Quote# 236172-4

| Bill To: McNeil Company Builders                    | Job Name: Ostronic Cabinets (Rev 9/1/26)                                             |

# CABINETRY DRAWINGS

Room: Kitchen

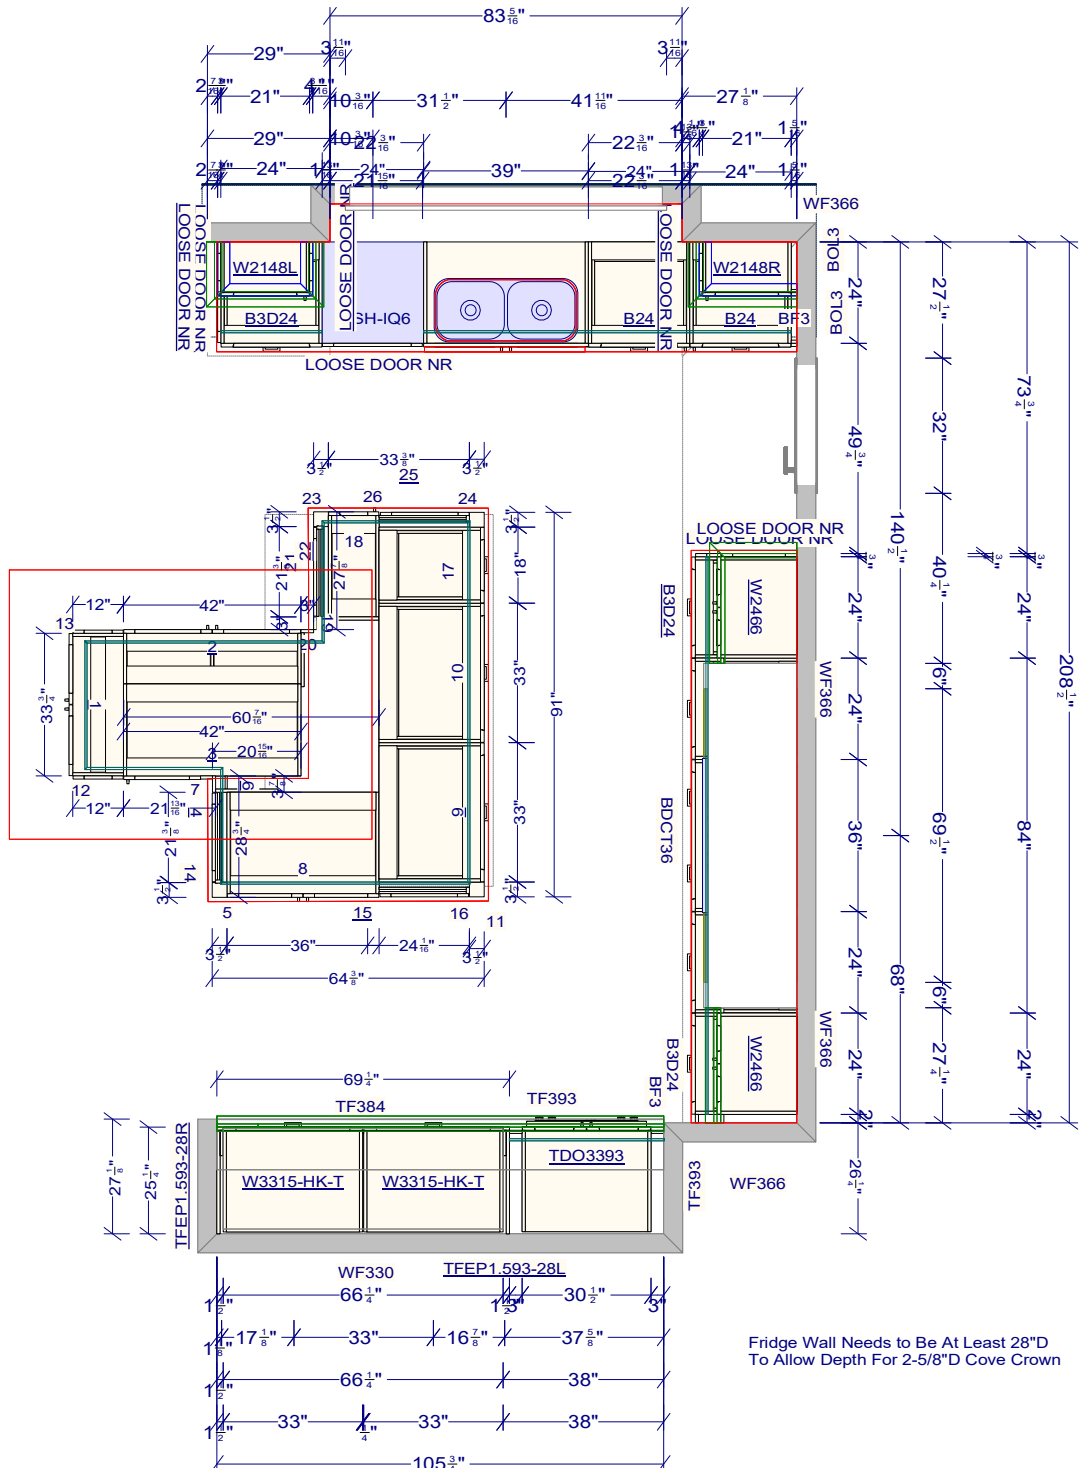
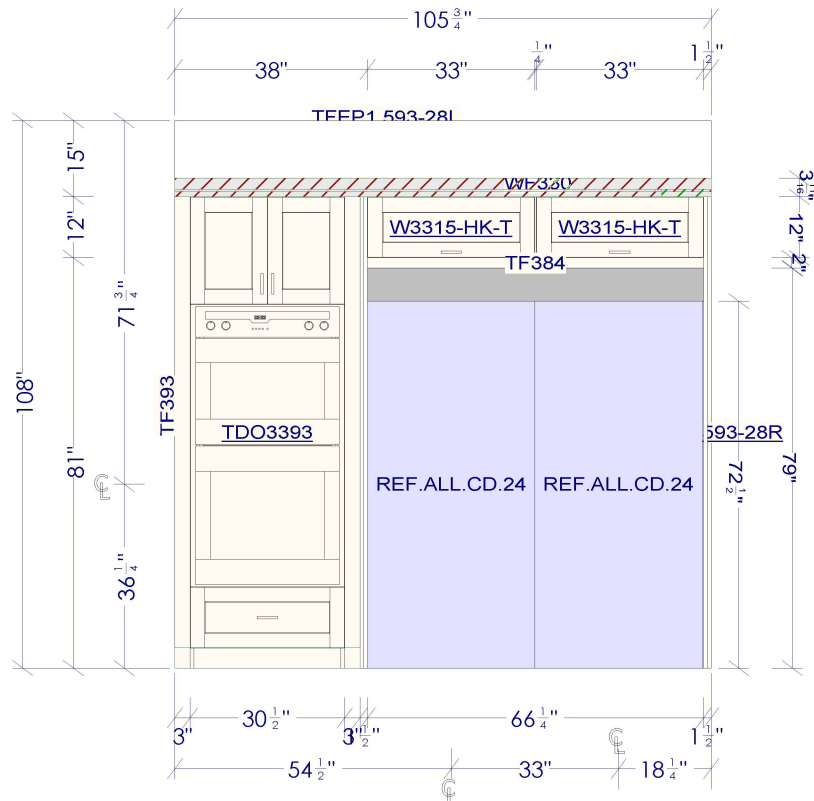
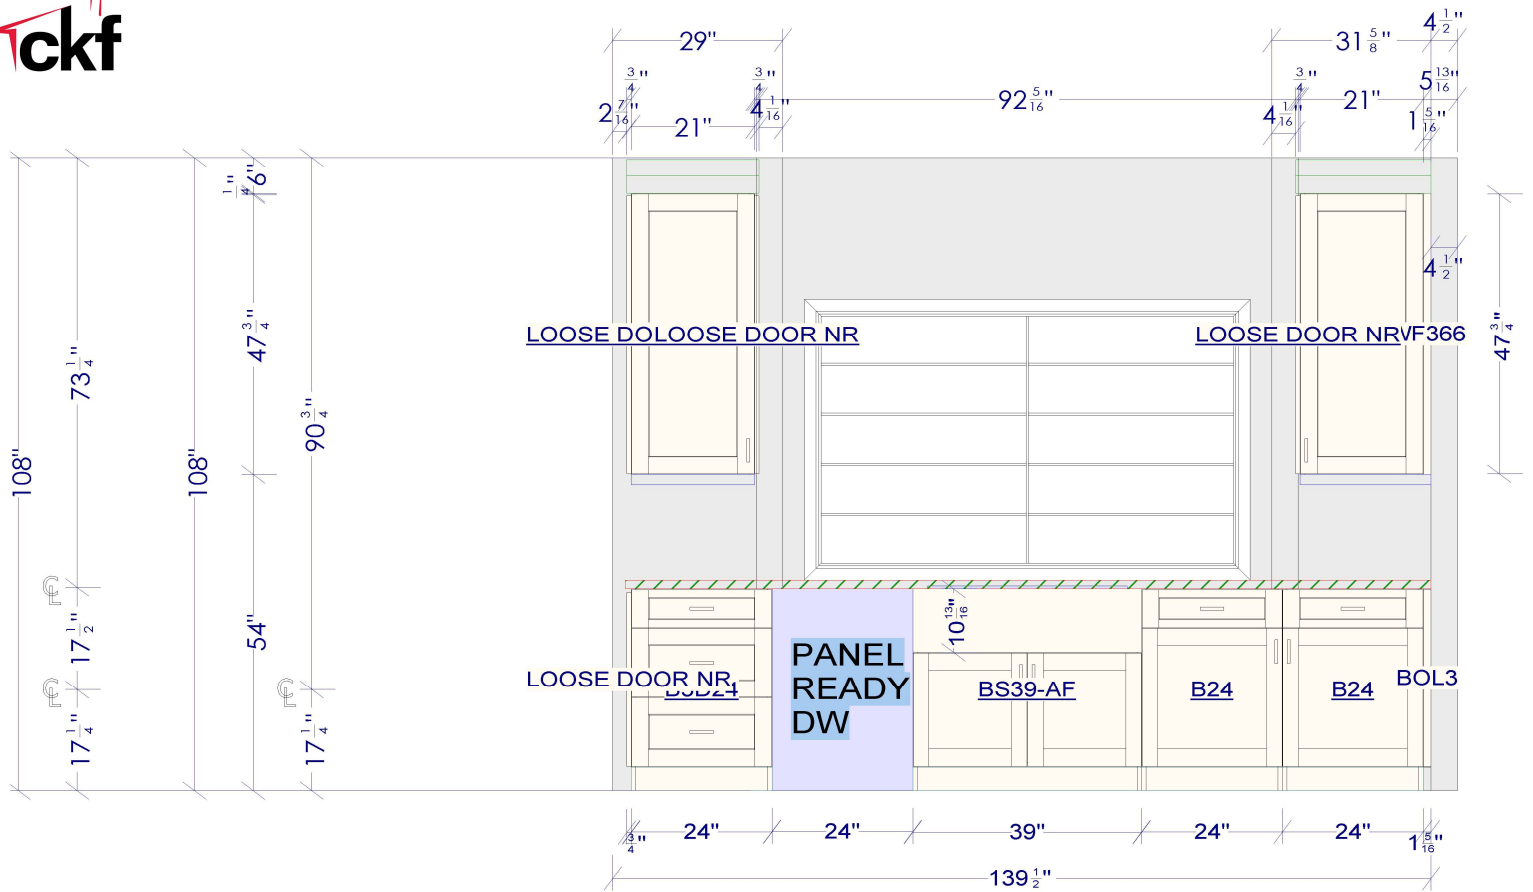
see McNeil  
elevations  
& update

see elevations

see McNeil elevation

wood hood by mcneil

Room: Dining

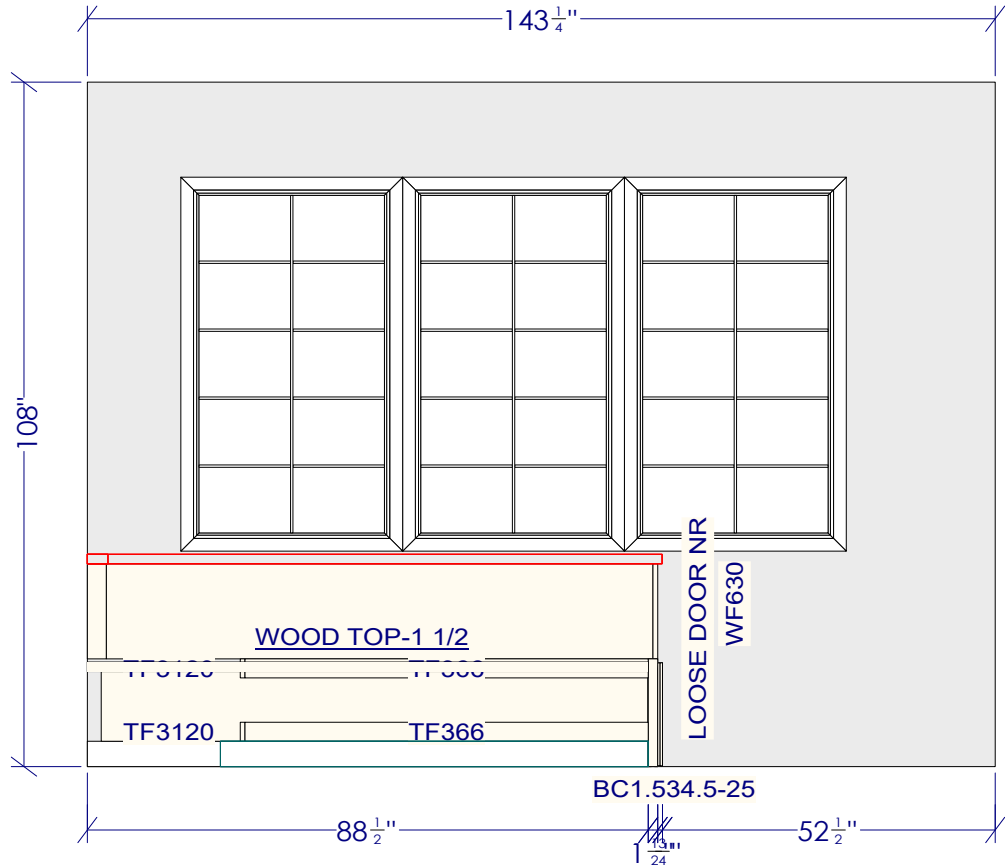
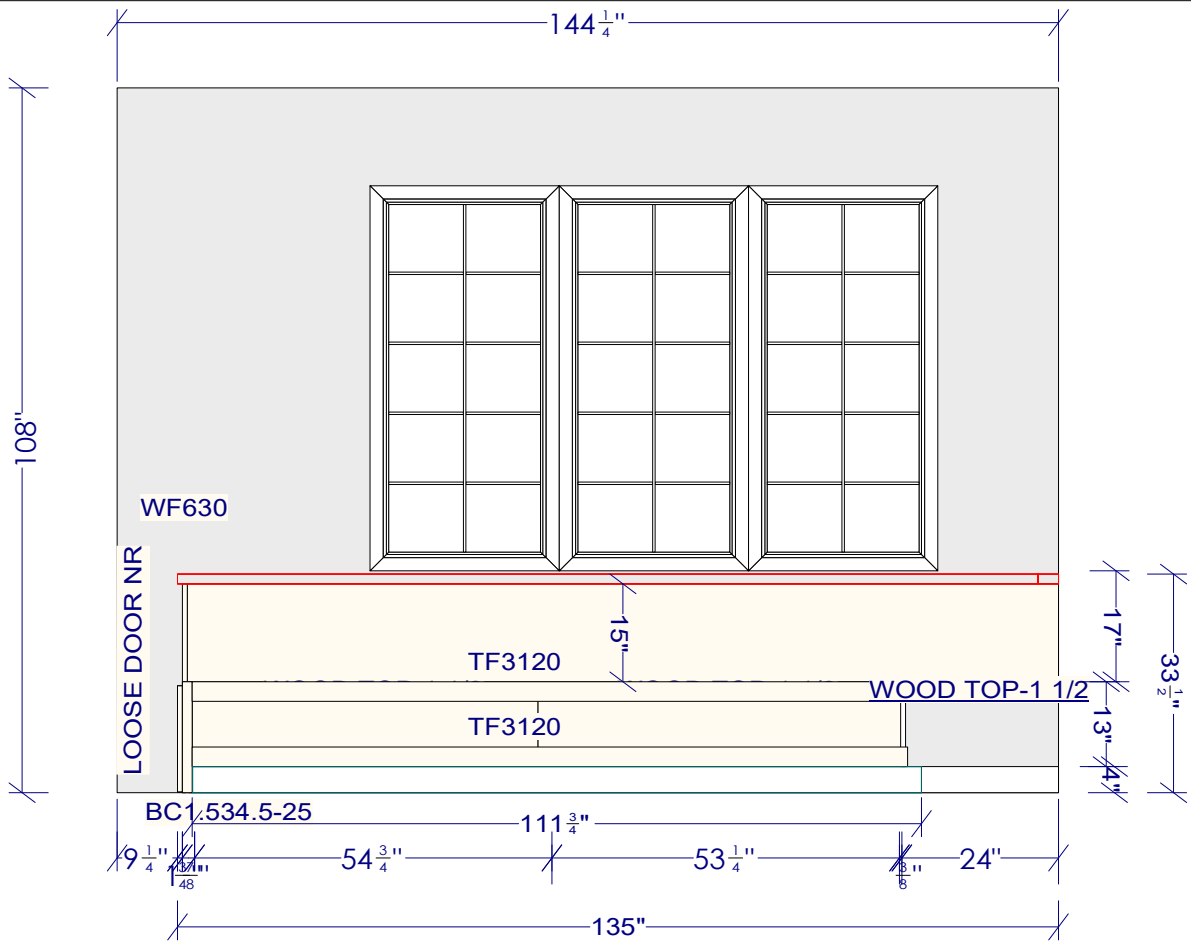
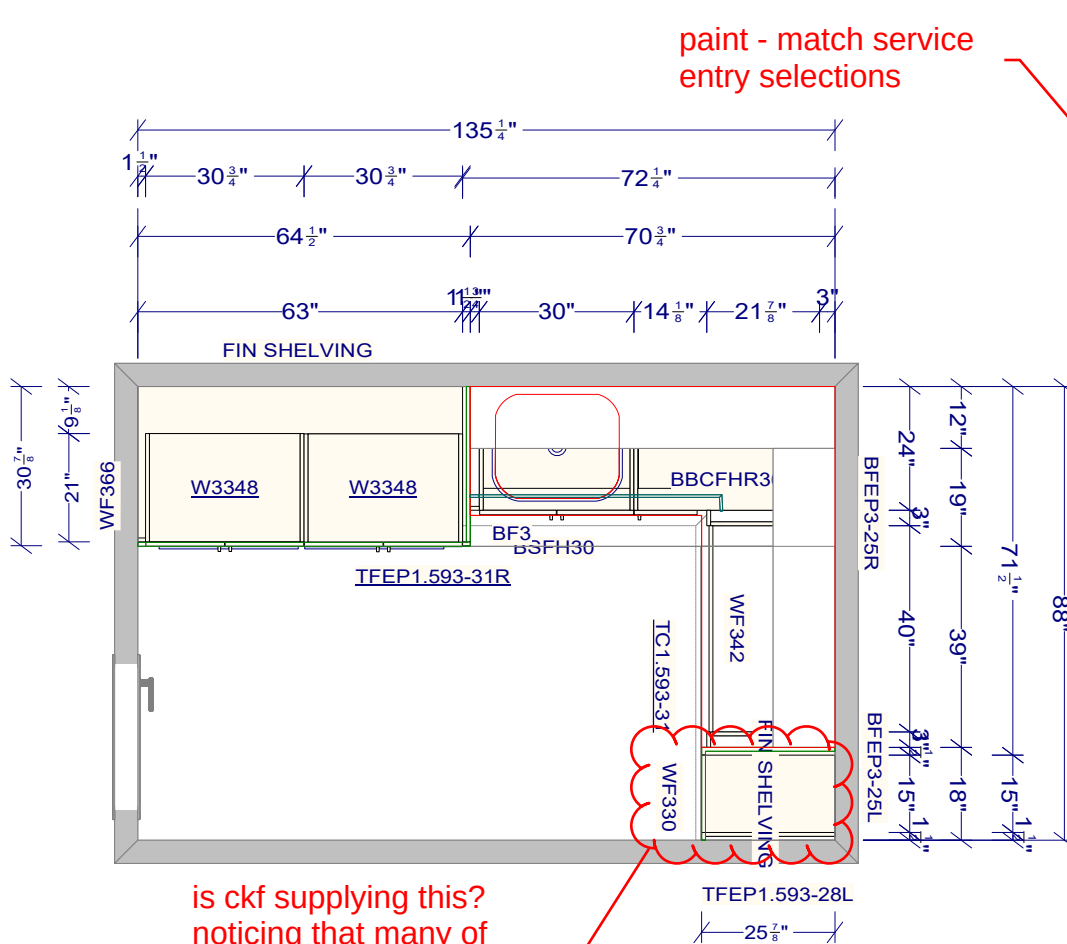
see McNeil drawing & update

slab fronts

white oak base bid,  
option maple

paint - match service  
entry selections

option classic

Room: Laundry

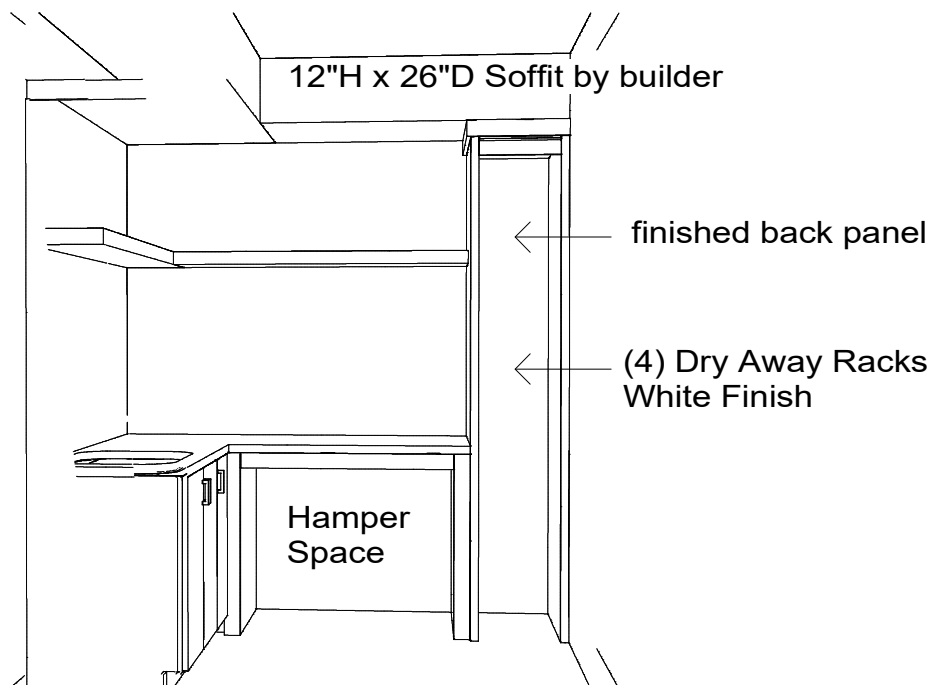
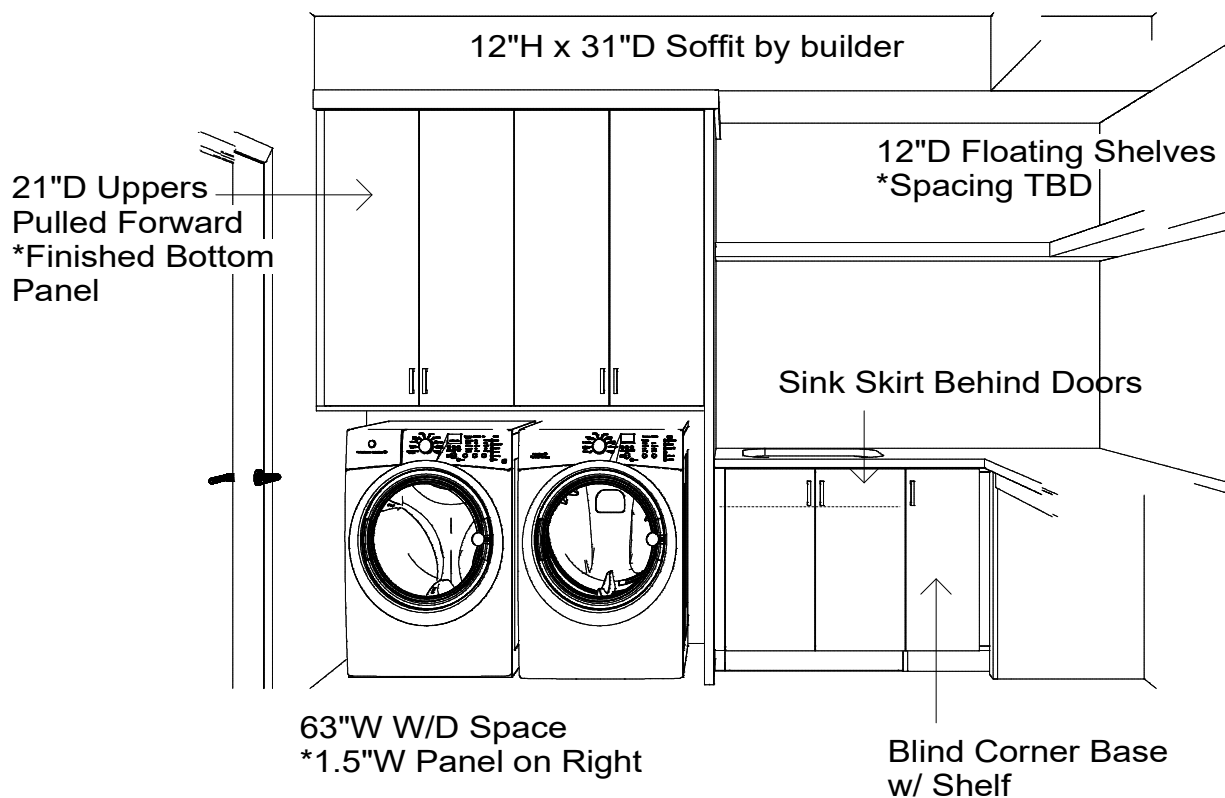
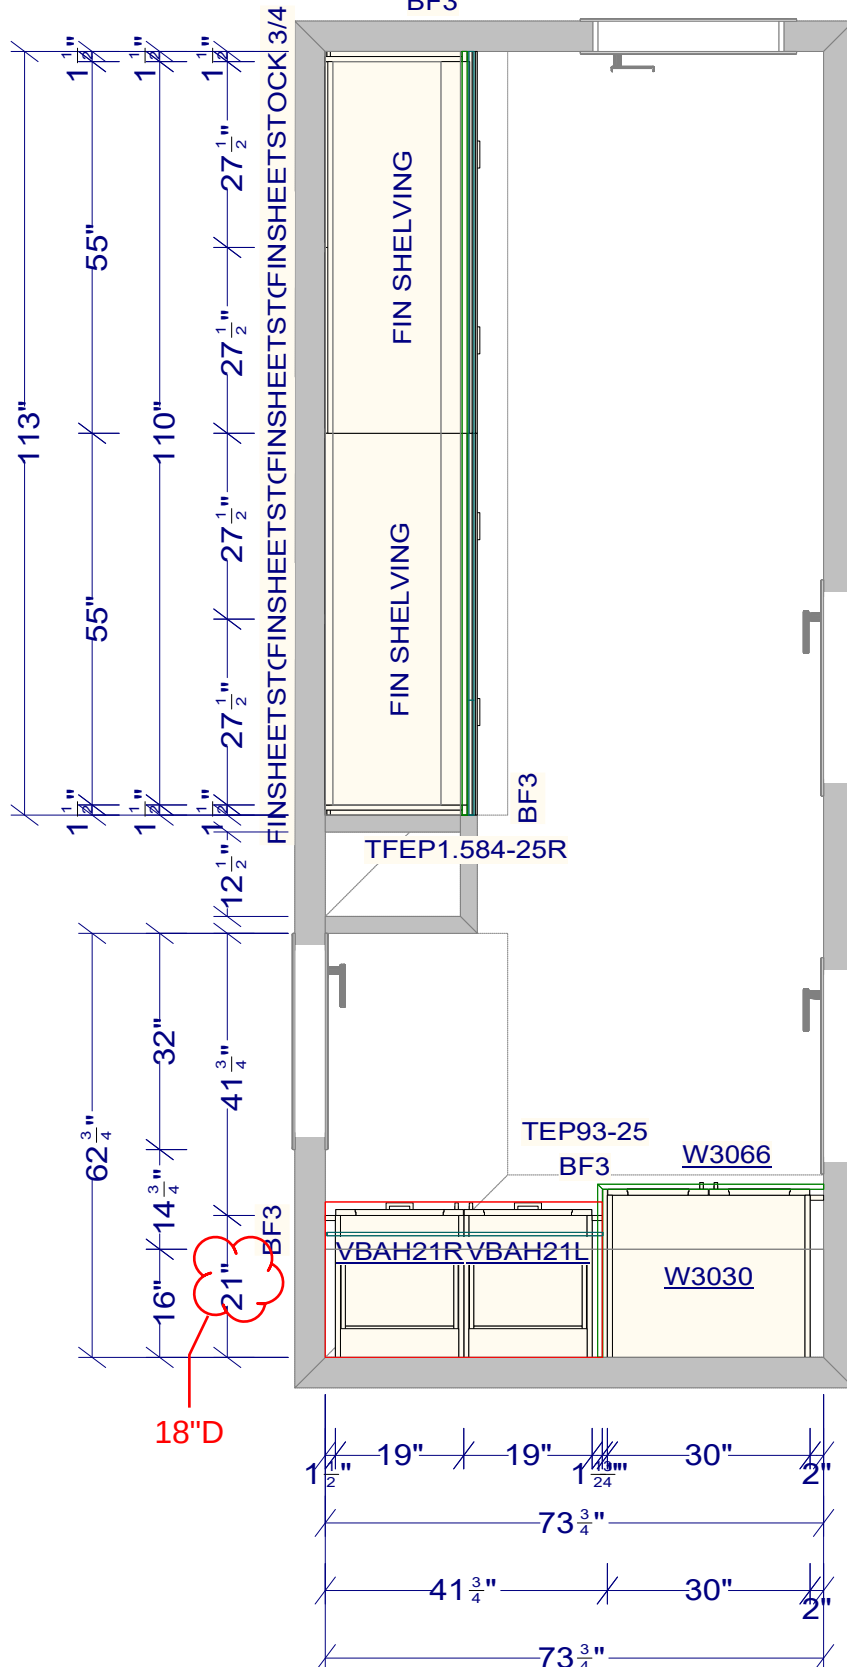
is ckf supplying this?  
noticing that many of  
these products are  
noting 30" minimum  
depth

see McNeil drawings & update

stained maple
